IN THE MATTER OF A PERMIT APPLICATION (AP-5873) FROM MEDICINE BOW FUEL & POWER, LLC TO CONSTRUCT AN UNDERGROUND COAL MINE AND INDUSTRIAL GASIFICATION AND LIQUEFACTION PLANT TO BE KNOWN AS THE MEDICINE BOW IGL PLANT

BEFORE THE
ENVIRONMENTAL QUALITY COUNCIL
STATE OF WYOMING

IN THE MATTER OF:)
MEDICINE BOW FUEL & POWER, LLC) DOCKET NO. 09-2801
AIR PERMIT CT-5873)

EXHIBIT 2
PERMITTEE'S RESPONSE TO APPEAL

Figure 1: Modeled Annual PM-10 Increment (% consumed)

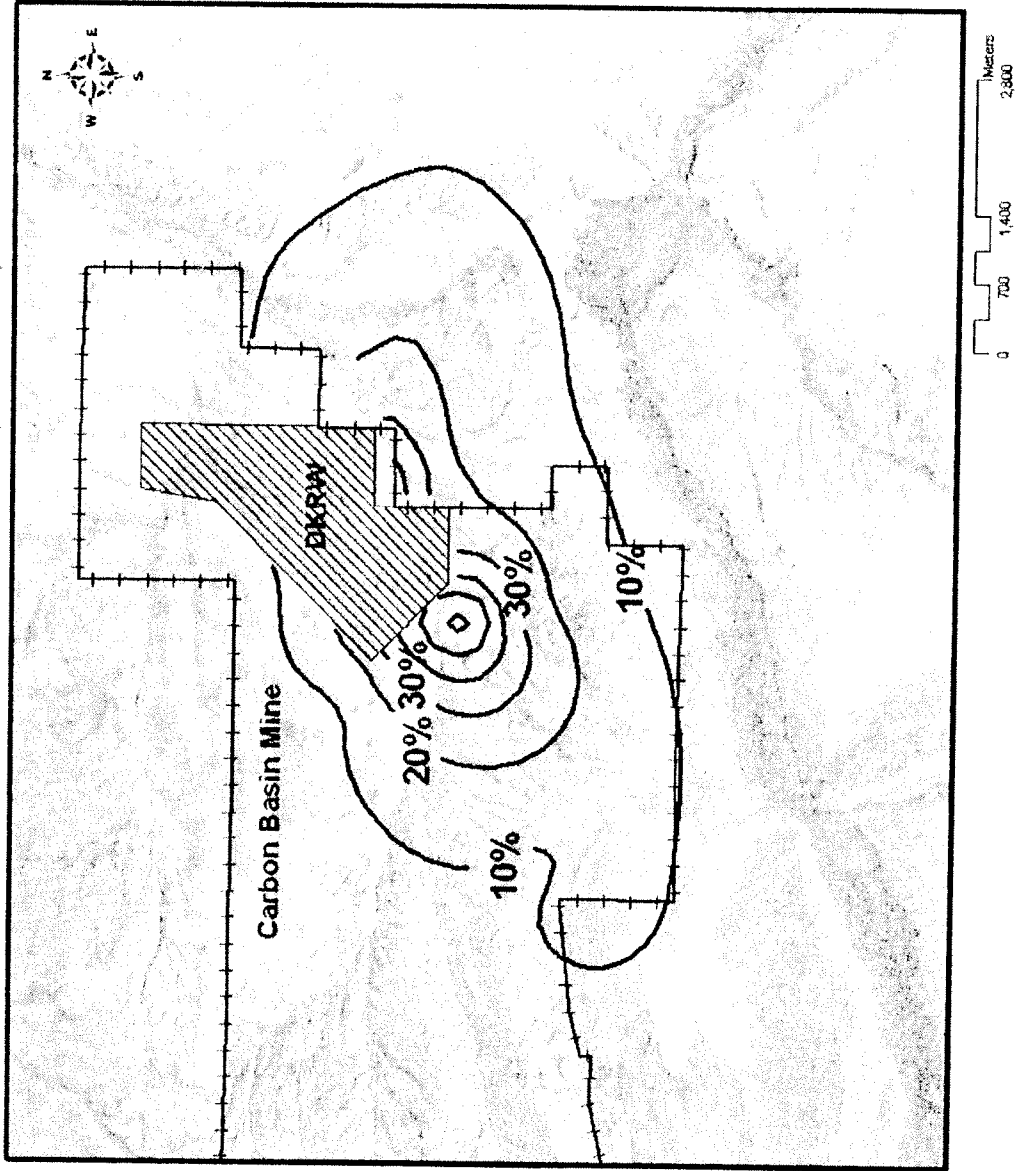
II.15 **Allowed particulate matter** – An individual commented that the plant will contribute up to 85% of the allowed particulate matter for the area, and raised several related questions:

Response – Emission controls for the project will consist of best available control technology (BACT). The Division's modeling analysis showed that 85% of the allowable PSD increment for PM₁₀ for the annual averaging period would be consumed near the proposed plant. The PSD increments are set at levels well below the NAAQS, and are designed to prevent newer sources from degrading the air quality in areas that attain the NAAQS. The area of relatively high increment consumption (> 50% of allowable level) is limited to an area on the western edge of the proposed facility boundary, which is contained within the boundary of the Carbon Basin Mine and not within the area considered "ambient" air available for public access. The extent of the modeled increment consumption is shown in Figure 1.

Response – The projected increment consumption was modeled with the proposed IGL plant sources and other nearby sources such as the neighboring coal mine, and therefore the current increment consumption (pre-IGL plant) was not considered. The results of the modeling indicate that the proposed facility will not prevent the attainment or maintenance of any air quality standard. The modeling domain did not extend to the Medicine Bow National Forest, which is located approximately 18 km to the southeast of the proposed project. The area of relatively high (> 50% of allowable level) increment consumption is predicted for an area at the west end of the boundary for the proposed project (see Figure 1).
